CITY OF DULUTH

STAFF REPORT

File Number	PL 14-064	Contact	Steven Robertson	
Application Type	MU-C Planning Review, Filling Station	Planning Commission Date	June 10, 2014	
Deadline for Action	Application Date	May 19, 2014	60 Days	July 18, 2014
	Date Extension Letter Mailed	May 22, 2014	120 Days	September 16, 2014
Location of Subject	Corner of Arlington and Central			
Applicant	Kwik Trip, Inc.	Contact		
Agent	Brad Fry	Contact	bfry@kwiktrip.com	
Legal Description	Lots 17 - 24, Block 1, Duluth Heights			
Site Visit Date	May 26, 2014	Sign Notice Date	May 27, 2014	
Neighbor Letter Date	May 22, 2014	Number of Letters Sent	35

City Planning
PL 14-064 and 14-065
Planning Review & Variance
Kwik Trip

PHOTOMETRIC SITE PLAN
SCALE: 1" = 20'-0"

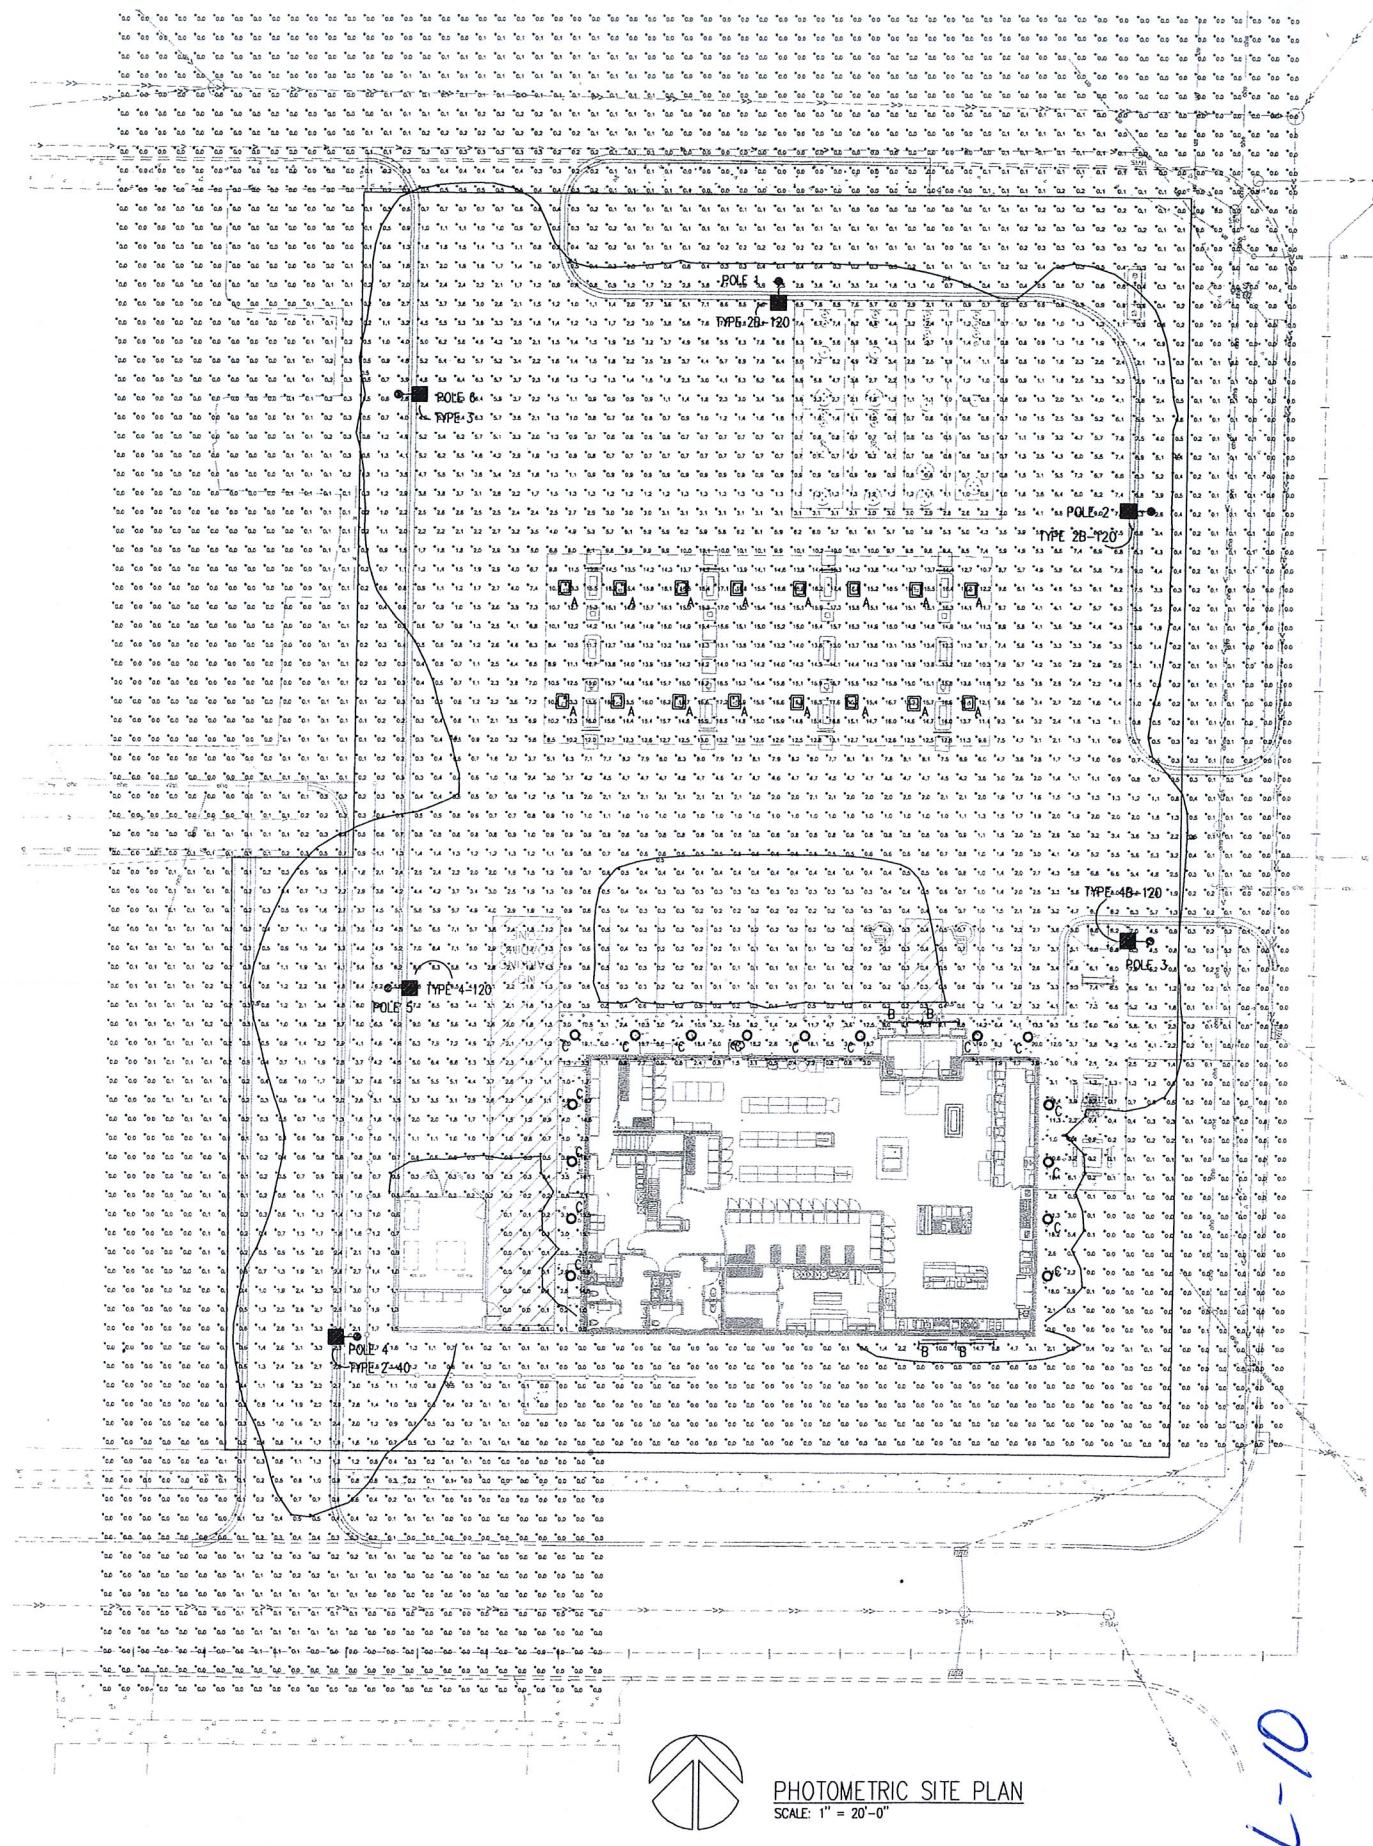
- 6) 50-29 (Sustainability Standards) and 50-30 (Building Design Standards). Not required because building is less than 10,000 sq ft.
- 7) 50-31 (Exterior Lighting). The lighting generally complies with the UDC, but there are a few areas that will need to be adjusted (lighting levels exceeded at the south property line near Pole 4, and near the gas canopy).

- 1) The project be limited to, constructed, and maintained according to site plans submitted, dated 2014-05-16.
- 2) Applicant revise lighting plan to show compliance with UDC section 50-31, Exterior Lighting.
- 3) If the variance is not approved by the Planning Commission, the applicant revise the parking plan to show compliance with front yard parking requirements.
- 4) Any alterations to the approved plans that do not alter major elements of the plan may be approved by the Land Use Supervisor without further Planning Commission; however, no such administrative approval shall constitute a variance from the provisions of Chapter 50.
